Description of Use Installing plumbing in three family dwelling.

RESIDENTIAL PLAN CORRECTION SHEET

ADDENDUM to Permit No. 656-77P
Owner Bergstedt & Sons
Location 1051 Dodd St.

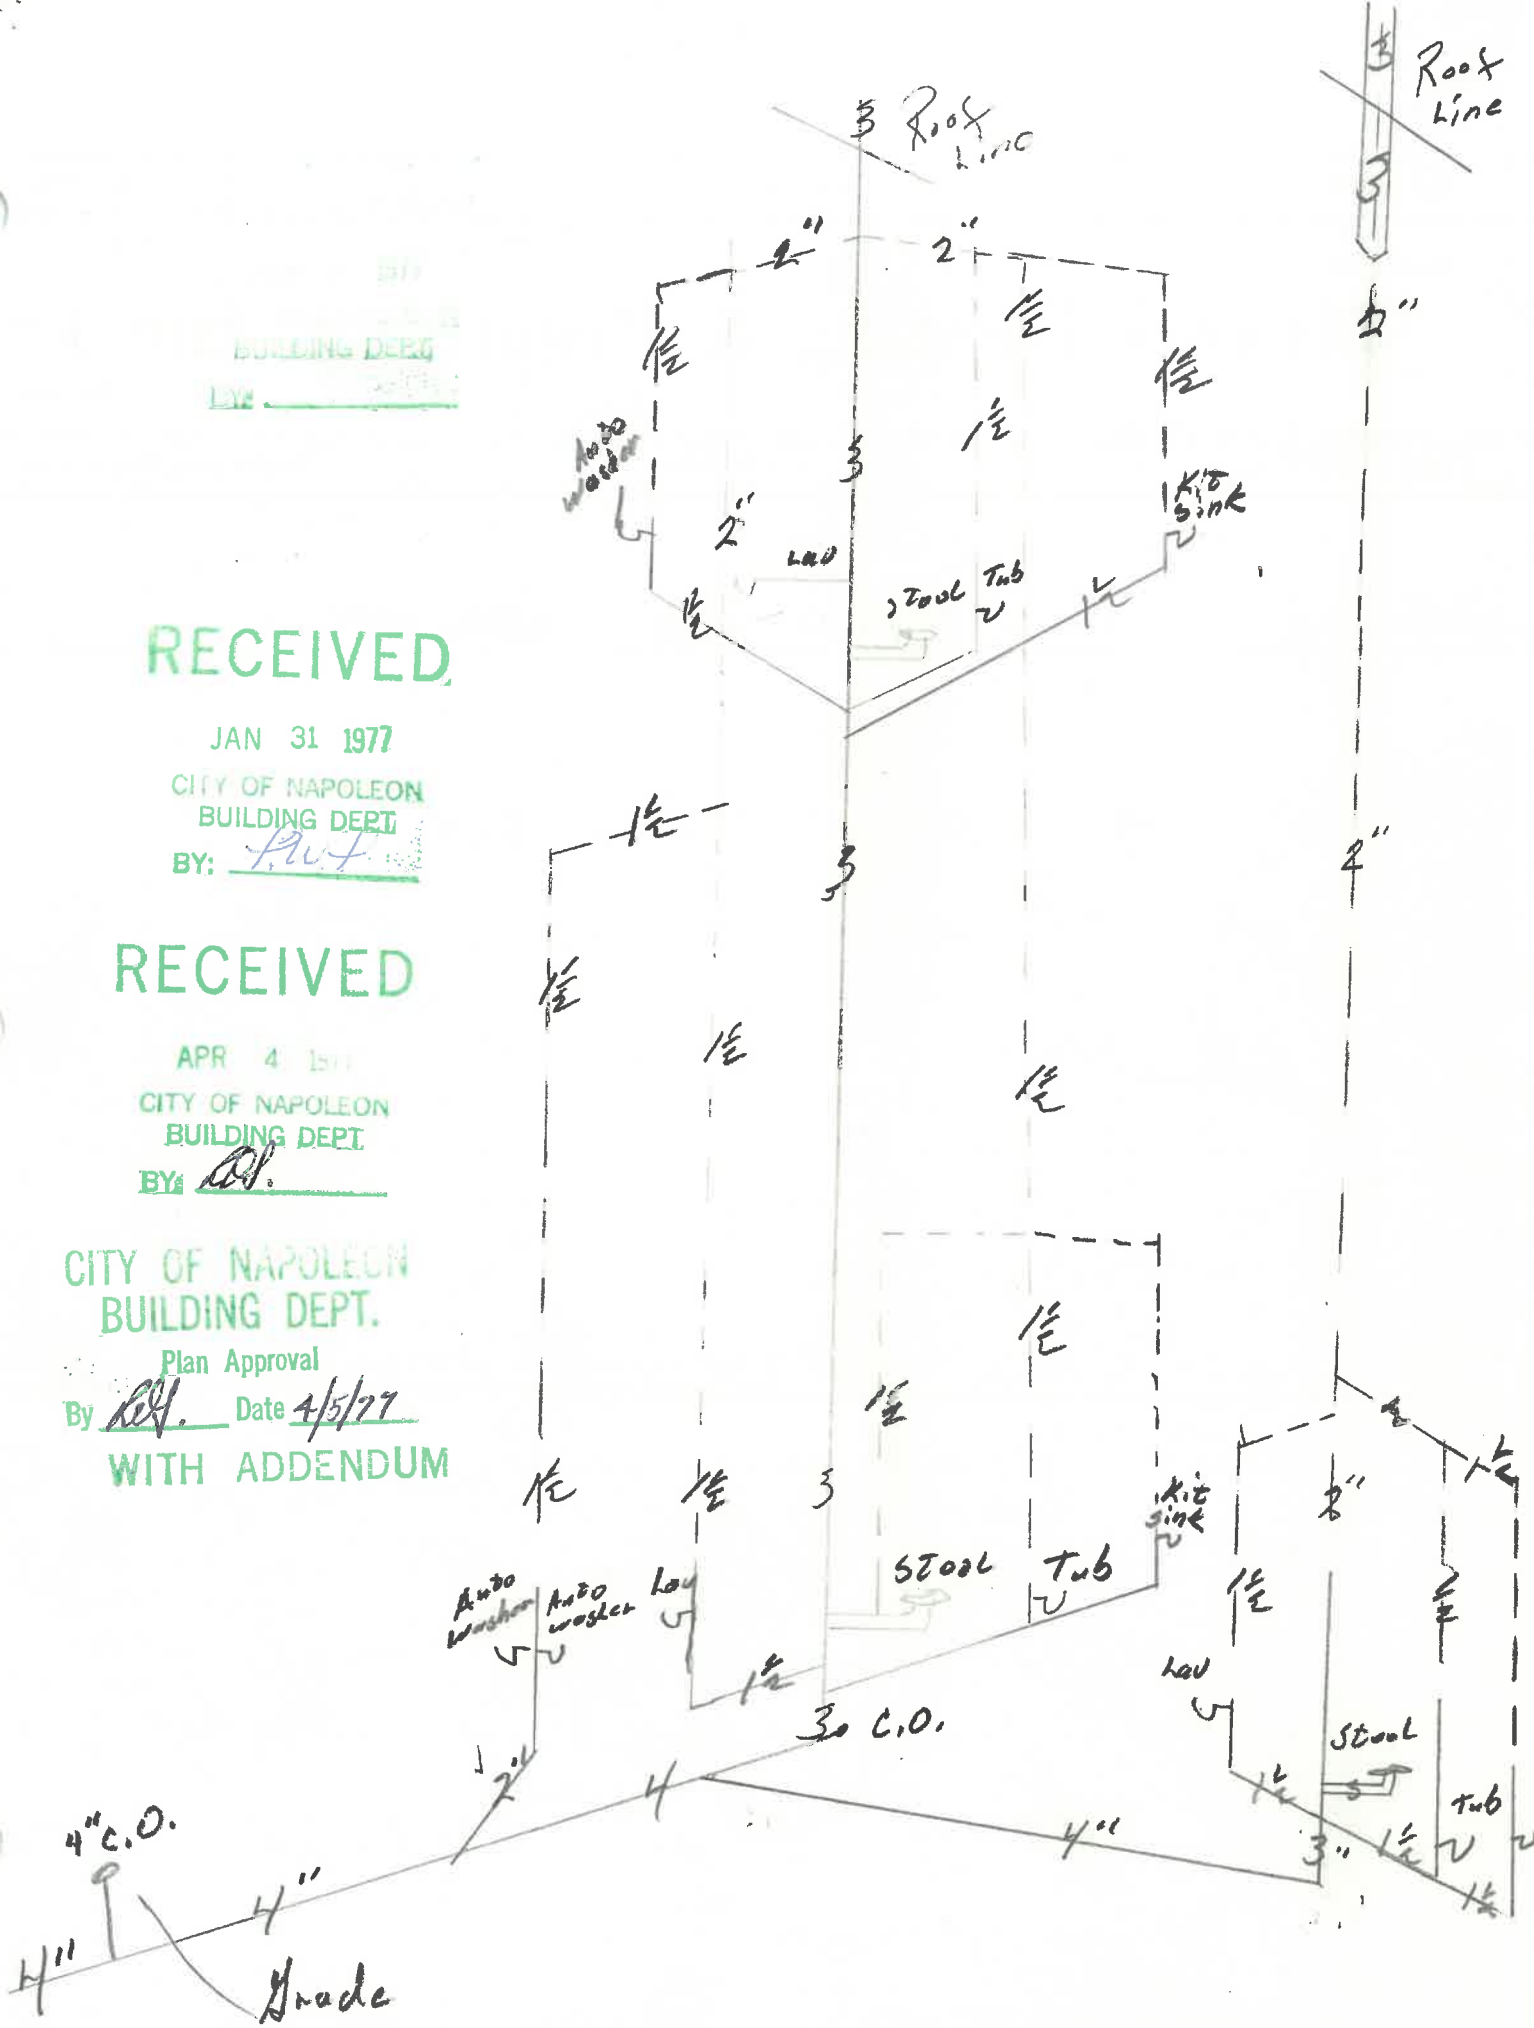
ADDITIONAL CORRECTIONS: Complete attached application and show kitchen fixtures on plumbing isometric. PROVIDE INDIRECT WASTE ON DISHWASHERS.
